SF705 A-G

Subject: Espar Fuel Standpipe Weld

SF705 – Inspection and Replacement of the Espar Fuel Standpipe

Fig. 1, Brass Standpipe Installed in the Fuel Tank

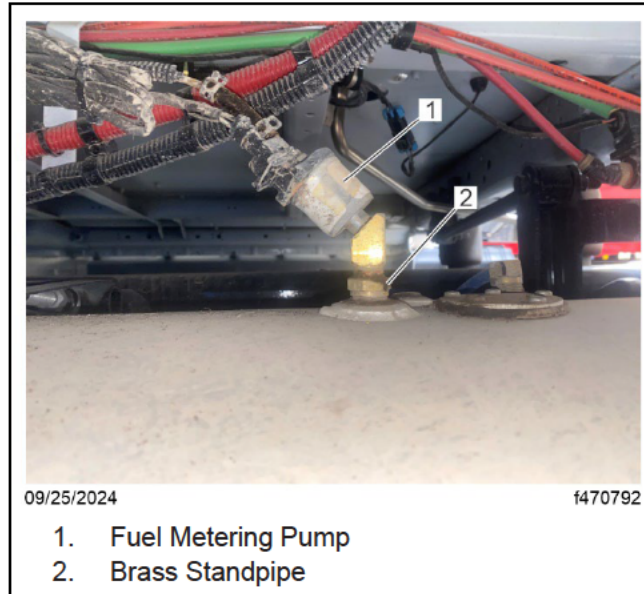
4. Locate the auxiliary heater fuel metering pump and standpipe mounted on top of the fuel tank.
5. Inspect the fuel standpipe to determine the material type of the fitting threaded to the fuel tank (7/8-inch hex fitting).
 - If a brass standpipe is installed, as shown in [Fig. 1](#), no further action is required. Go to step 16.
 - If a nickel-plated steel (shiny/chrome at 7/8-inch hex) standpipe is installed, continue with step 6.
